Randolph Pump Station Improvements Project
Solicitation Number: CO-00459
Job No.: 20-8611

ADDENDUM NO. 6
January 18, 2023

14. Sheet E-3 Existing Site Layout Demolition and Temporary Relocation

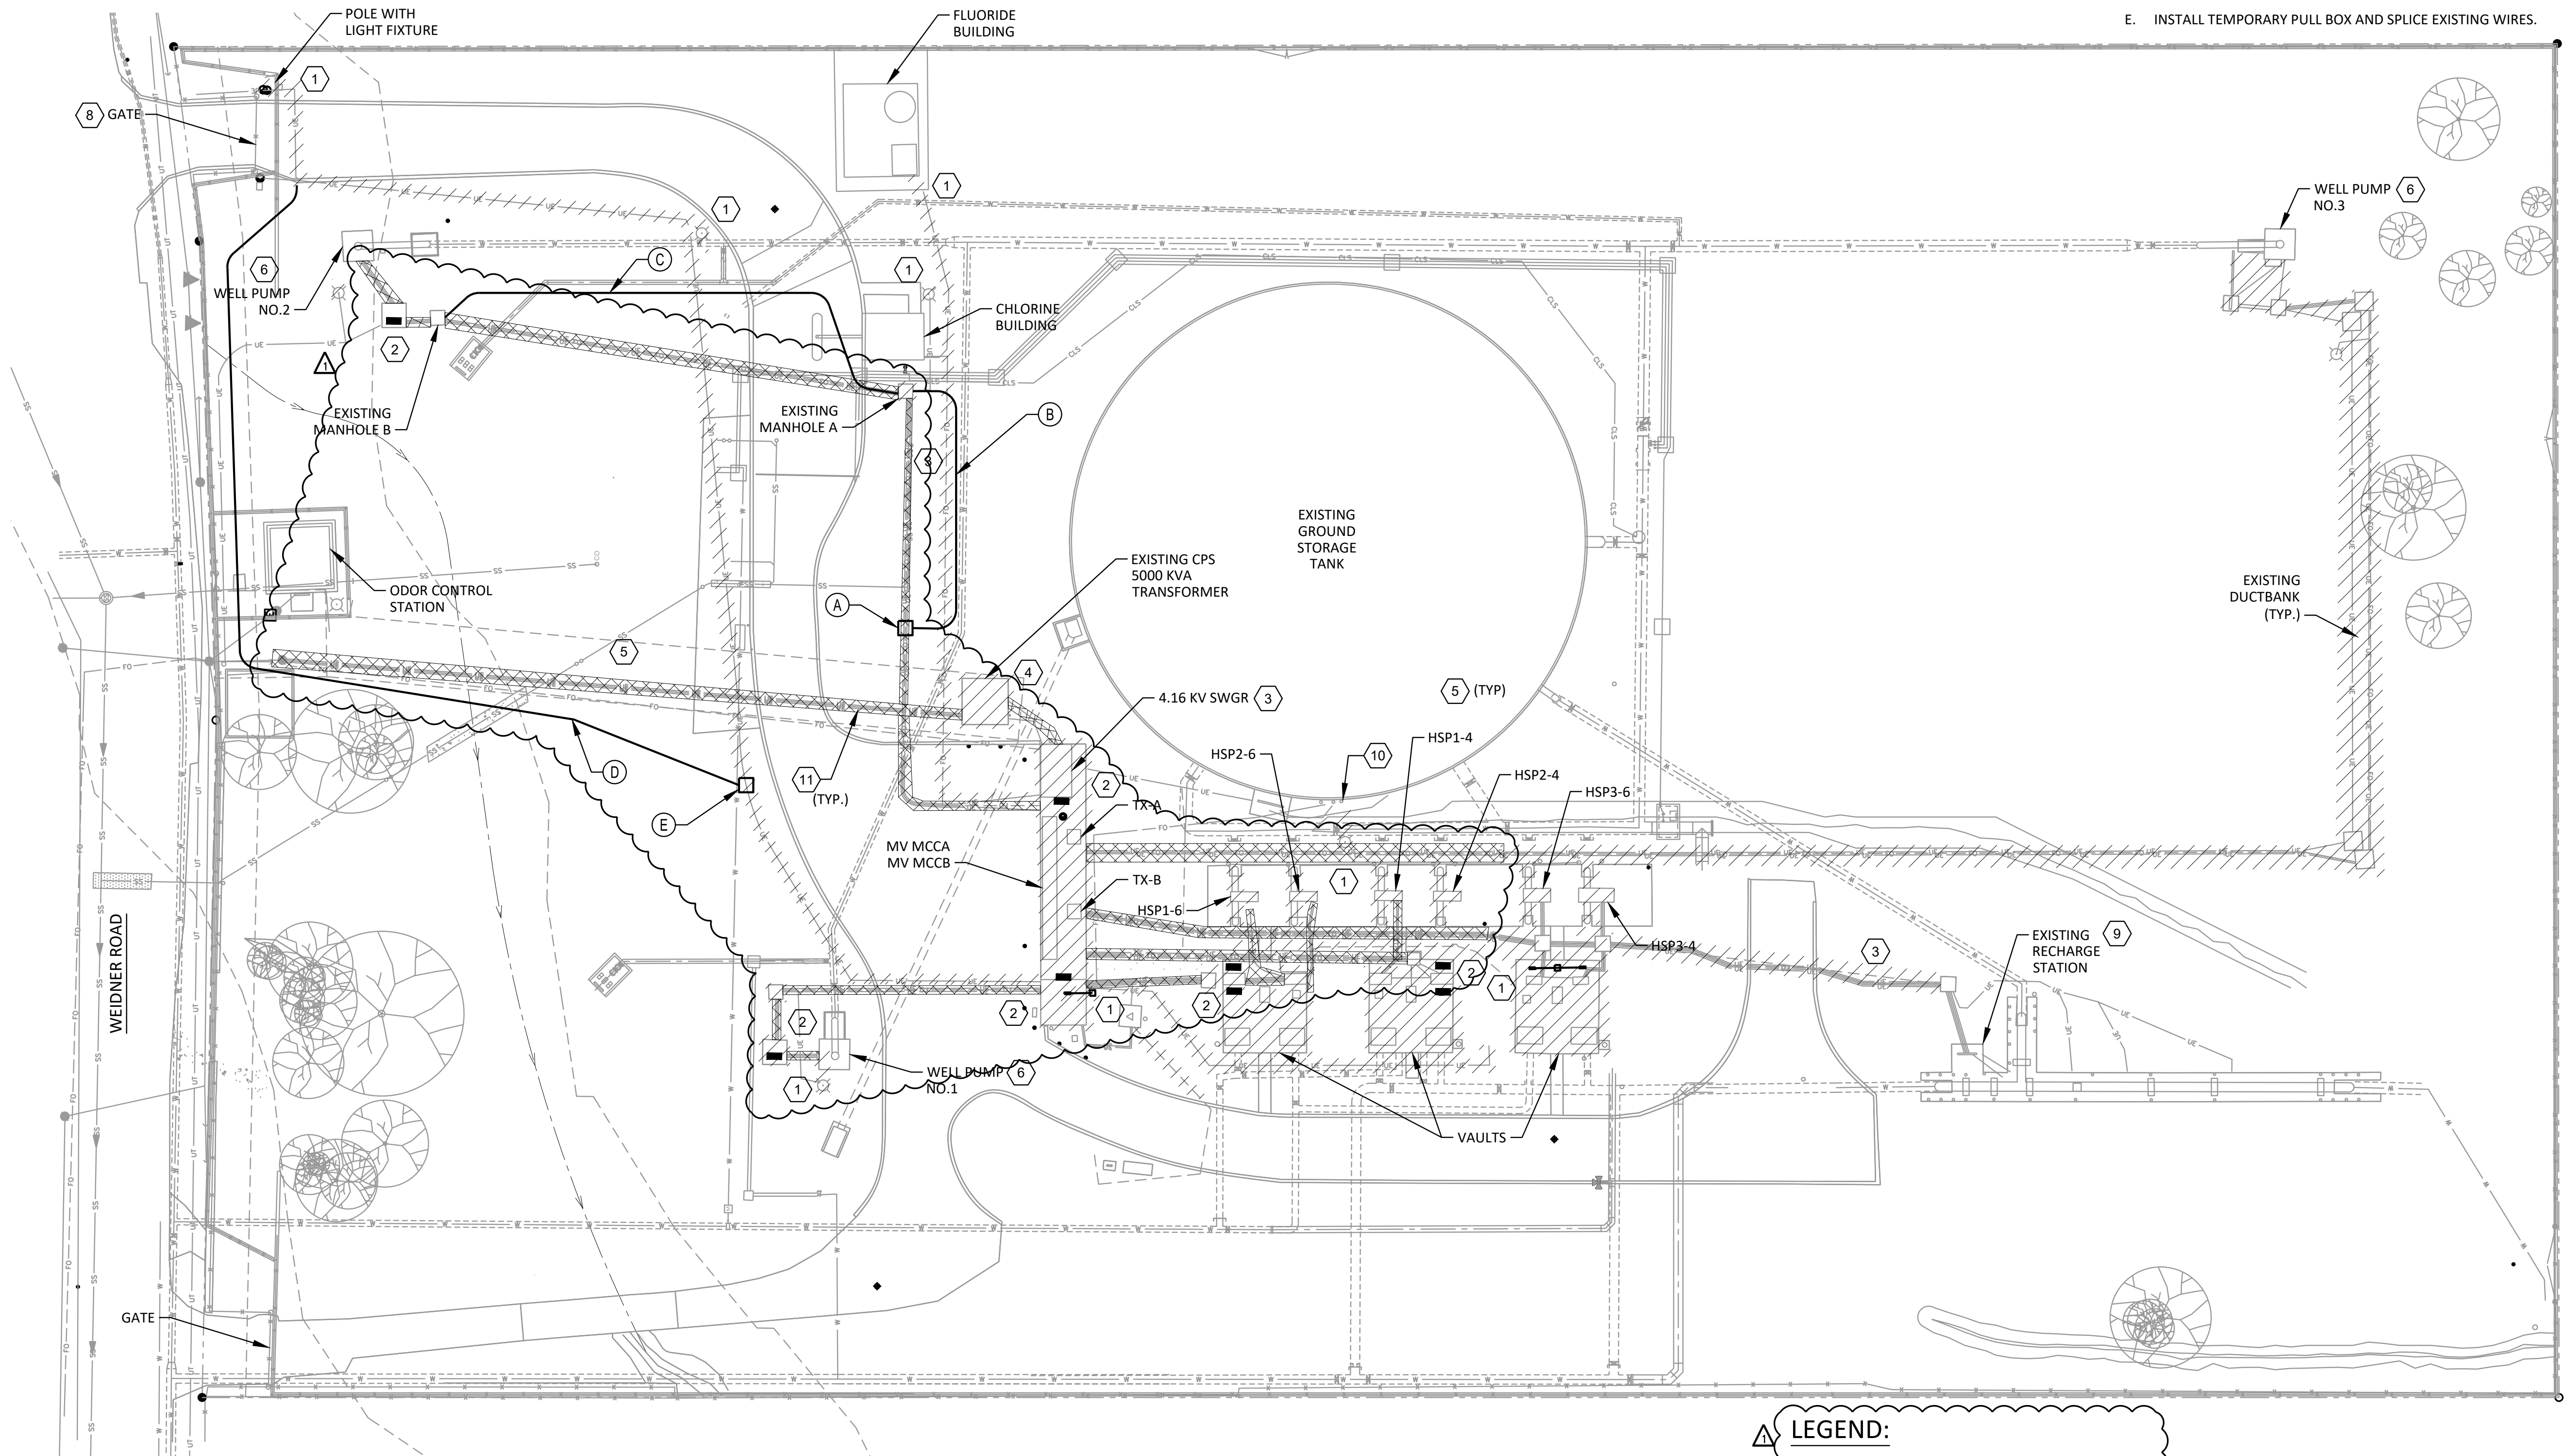
- 42. Question: Reference drawing E-3. Clarify General Notes 8 and 12 concerning existing duct banks to be removed. Are existing duct banks allowed to be abandoned in place per Note 8, or are duct banks required to be removed per Note 12?**

Response: All existing underground ductbanks are to be removed. See Item No. 14 in the CHANGES TO THE PLANS section of this addendum for the update to Sheet E-3.

Response: The approximate quantity of electrical ductbank containing asbestos to be removed is 1,250 LF. Prior to removal of the ductbank, the Contractor shall procure an environmental testing service to confirm the extent of the asbestos-containing ductbanks and the proper disposal of the asbestos. See Item No. 14 in the CHANGES TO THE PLANS section of this addendum for the update to Sheet E-3.

15. Sheet E-4 Site Layout - Modification

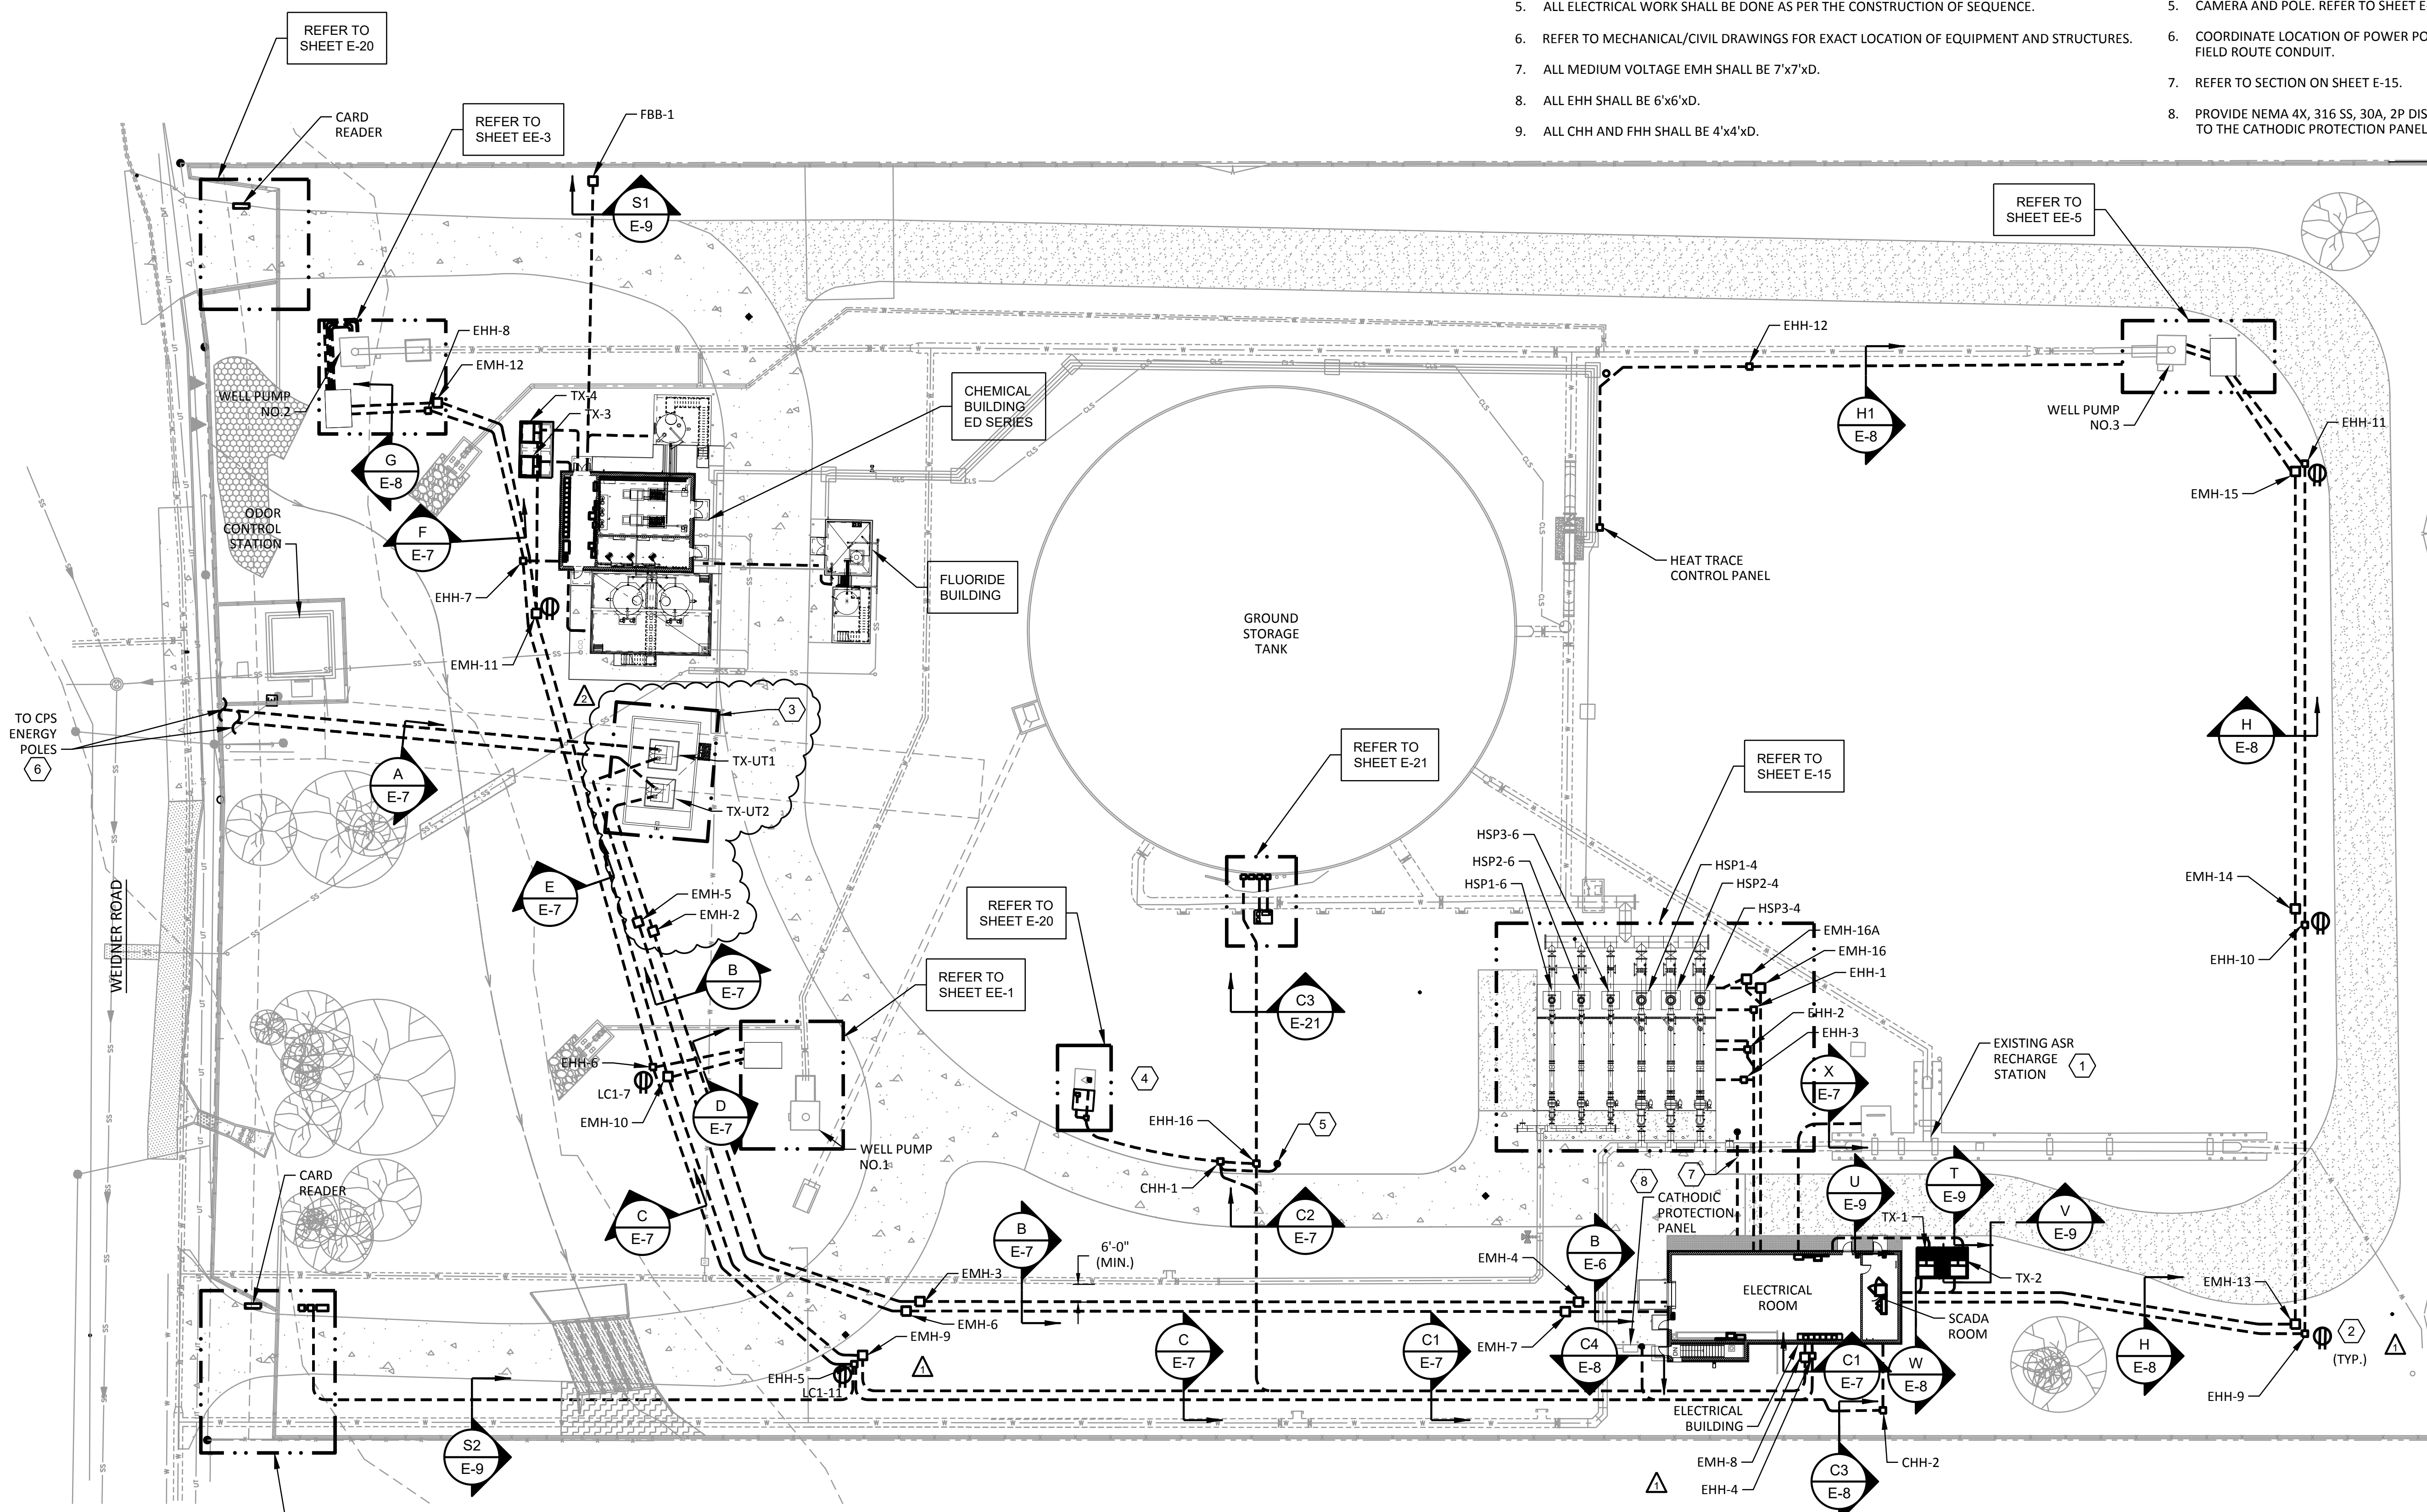
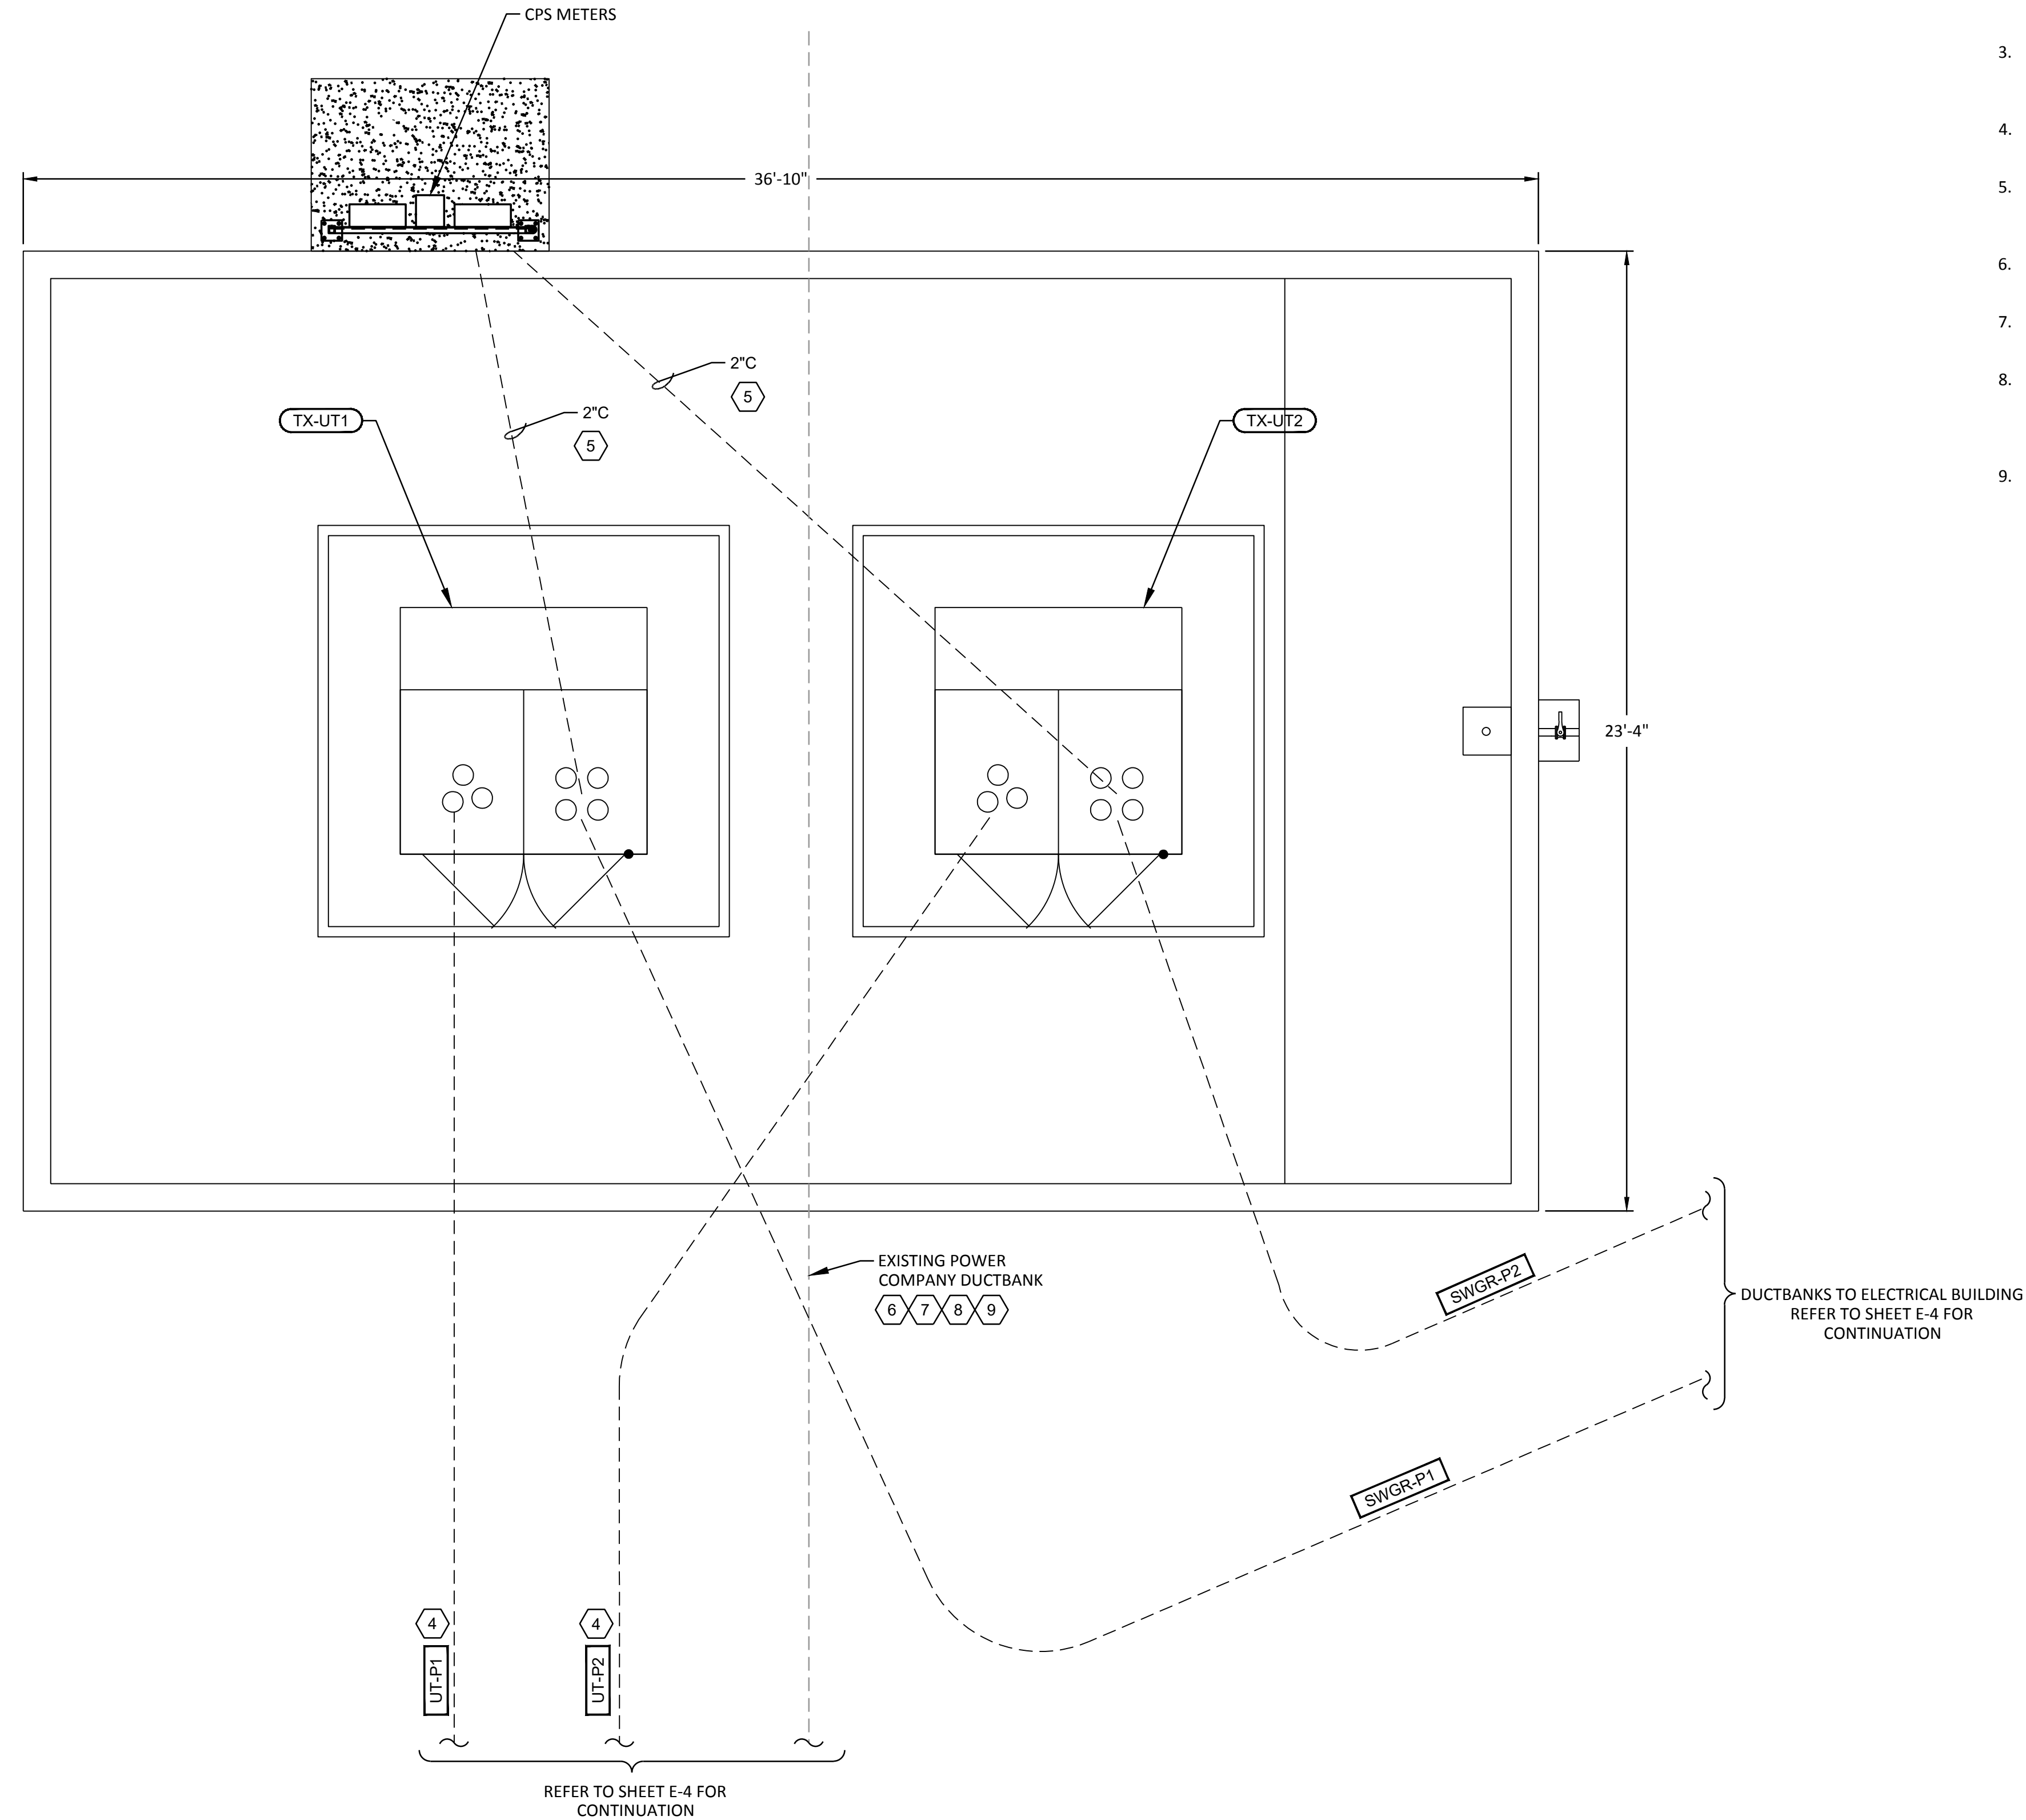
- a. **Delete** electrical manholes EMH-1 and EMH-1A as modified on Sheet E-4 included in this addendum.
- b. **Modify** transformer TX-UT1 and TX-UT2 pad and containment as shown on Sheet E-4 included in this addendum.
- c. **Move** electrical manholes EMH-2 and EMH-5 as modified on Sheet E-4 included in this addendum.
